ADDENDUM NO. 02

October 28, 2026

Franklin Central High School Health Sciences Pavilion
6215 S. Franklin Rd
Indianapolis, IN 46259

TO: ALL BIDDERS OF RECORD

2 A402 **WALL SECTION** 3/4" = 1'-0"

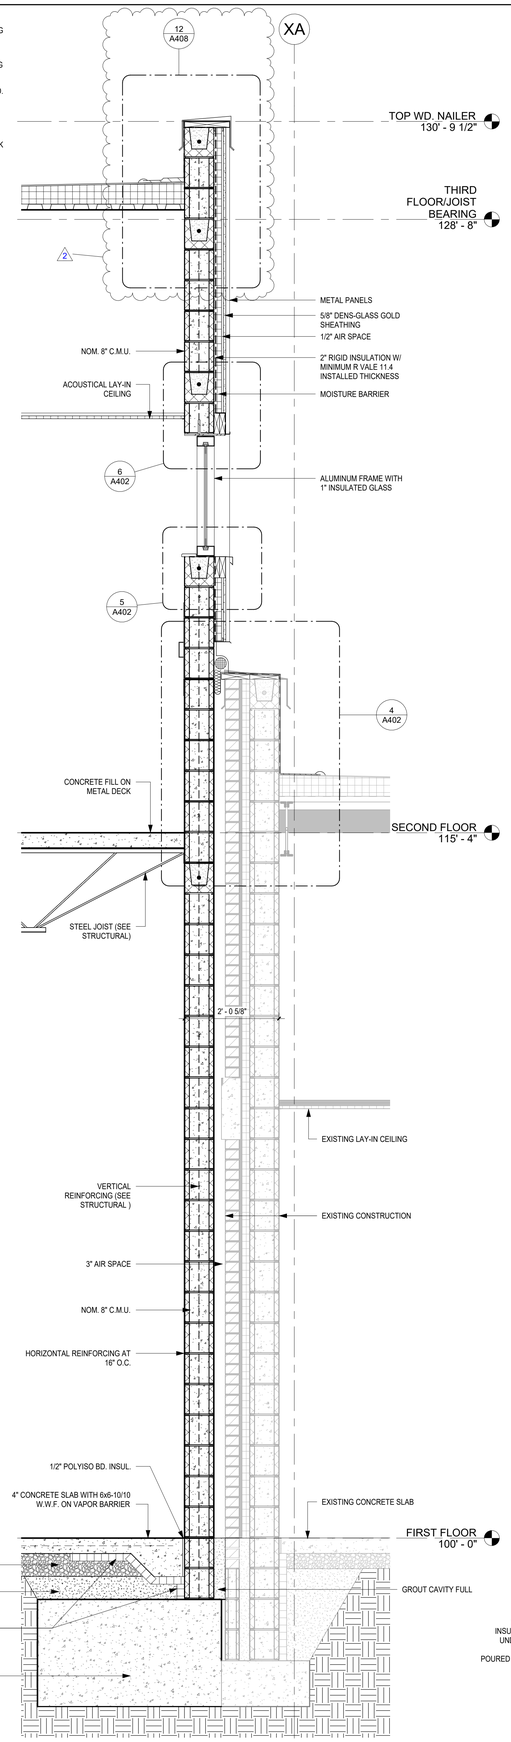
3. **Q:** Is MC cable permitted on this project? If so, in which applications may it be used?
   A. No, MC is not acceptable for use.
4. **Q:** A301 (no north elevation); A402 sections 1 and 2; A601 details 1 and 2 (Add #1); A101HSP/A102HSP keynote 1. No north elevation is provided. Please confirm the finishes and extent of masonry on the 2nd-floor north wall above the existing roof and at tie-ins to the existing building.

A. Sections 2/A402 and 1/A406 show the extent of masonry and metal wall cladding on the North elevation above the roof, including tile into the existing roofing.

TYPICAL EXTERIOR WINDOW FRAME ELEVATIONS

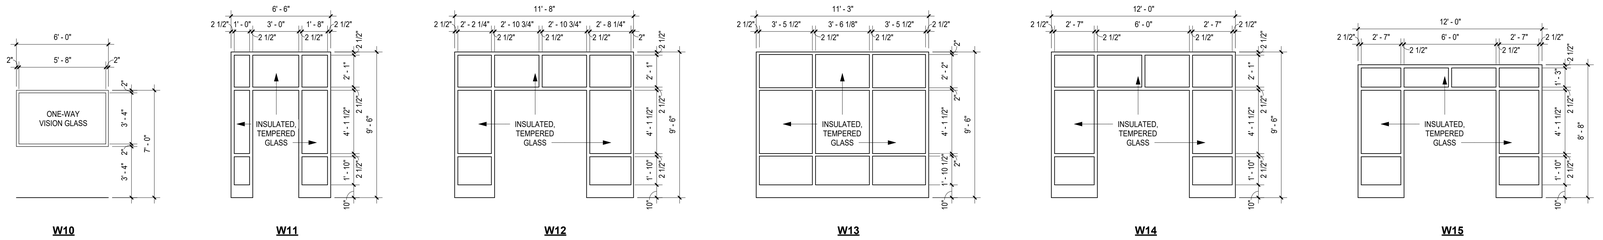
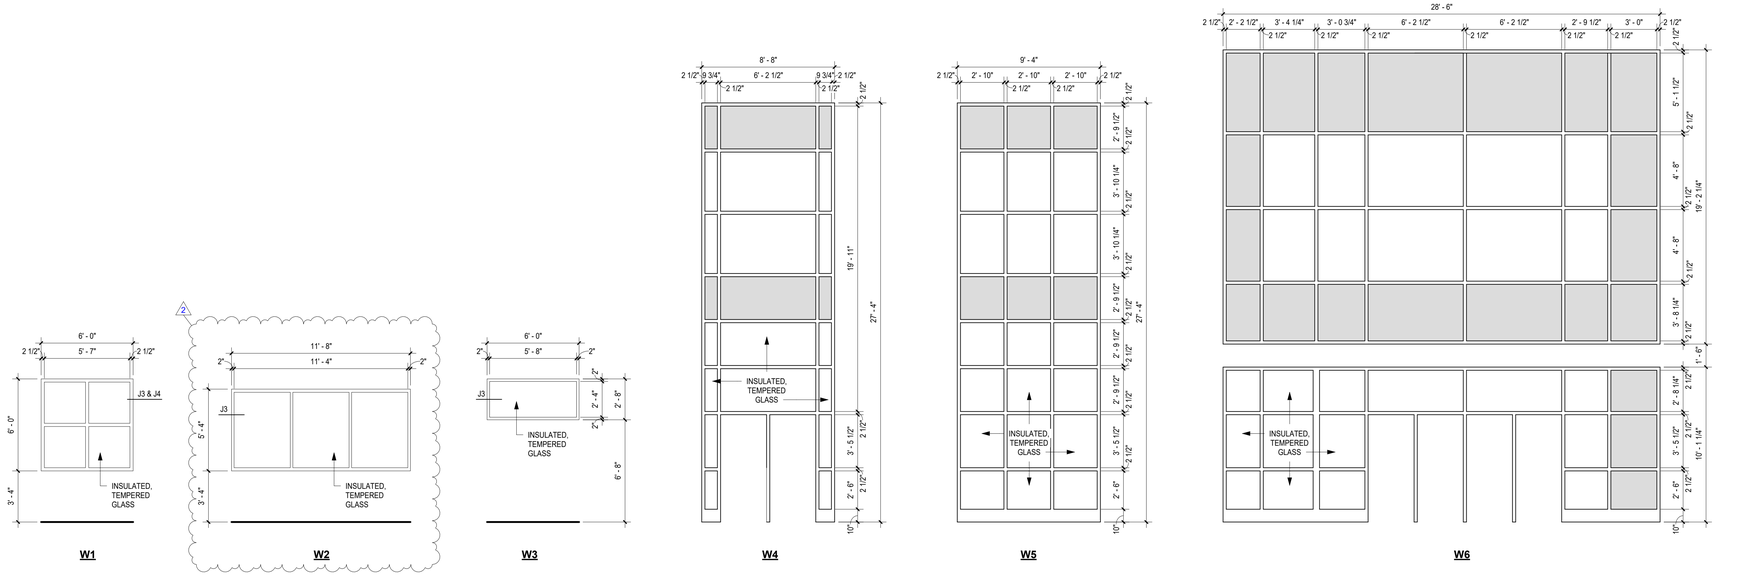
10. **Clarification:** All Ballistic resistant glazing was removed from the project with Addendum #1 reissued 08 80 00 Glazing Specification. Replace ballistic glazing with Security glazing laminate, basis of design product “Safe Haven.” Noted as “Riot Film” on Sheet A702.

NOTE: PROVIDE RIOT FILM ON VESTIBULE SIDE OF GLAZING - TYPICAL W11, W12, AND W13
